UNITED STATES PATENT AND TRADEMARK OFFICE

APPLICATION NO.	FILING DATE	FIRST NAMED INVENTOR	ATTORNEY DOCKET NO.	CONFIRMATION NO.
10/674,623	09/30/2003	Bobbye Kaye Whitenton Baylis	2002P16242US01;60,427-605 4194	
24500 7	24500 7590 12/02/2005		EXAMINER	
	ORPORATION	GARCIA, ERNESTO		
INTELLECTUAL PROPERTY LAW DEPARTMENT 170 WOOD AVENUE SOUTH			ART UNIT	PAPER NUMBER
ISELIN, NJ (08830		3679

Application No.	Applicant(s)			
,	10/674,623	BAYLIS ET AL.			
Office Action Summary	Examiner	Art Unit			
	Ernesto Garcia	3679			
The MAILING DATE of this communication appears on the cover sheet with the correspondence address Period for Reply					
A SHORTENED STATUTORY PERIOD FOR REPLY WHICHEVER IS LONGER, FROM THE MAILING DA - Extensions of time may be available under the provisions of 37 CFR 1.13 after SIX (6) MONTHS from the mailing date of this communication. - If NO period for reply is specified above, the maximum statutory period w - Failure to reply within the set or extended period for reply will, by statute, Any reply received by the Office later than three months after the mailing earned patent term adjustment. See 37 CFR 1.704(b).	ATE OF THIS COMMUNICATION 36(a). In no event, however, m

Lohr, 6,267,093

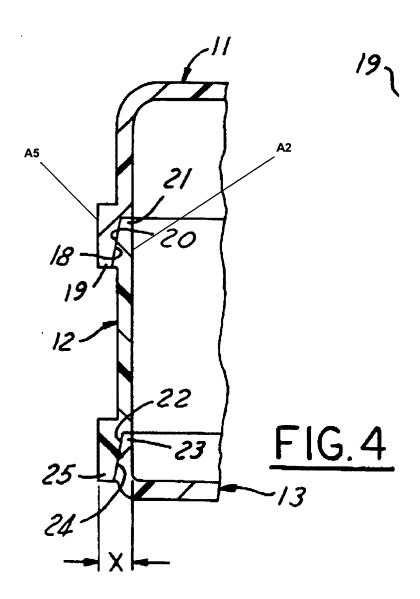
Claims 1, 2, and 5 are rejected under 35 U.S.C. 102(b) as being anticipated by Lohr, 6,267,093.

Regarding claim 1, Lohr discloses, in Figure 4, a laser weld comprising a first component portion 11 and a second component portion 12. The first component portion 11 defines a first laser weld surface A2 and includes a first taper surface 18 opposite from the first laser weld surface A2. The second component portion 12 defines a second laser weld surface A5 and includes a second taper surface 20

opposite from the second laser weld surface **A5**. The first taper surface **18** and the second taper surface **20** cooperate with each other.

Regarding claim 2, the first component portion **11** comprises an upper shell; the second component portion **12** comprises a lower shell. The upper shell **11** and the lower shell **12** together form an air induction component.

Regarding claim 5, the first taper surface or the second taper surface defines a taper angle of at least thirty degrees.
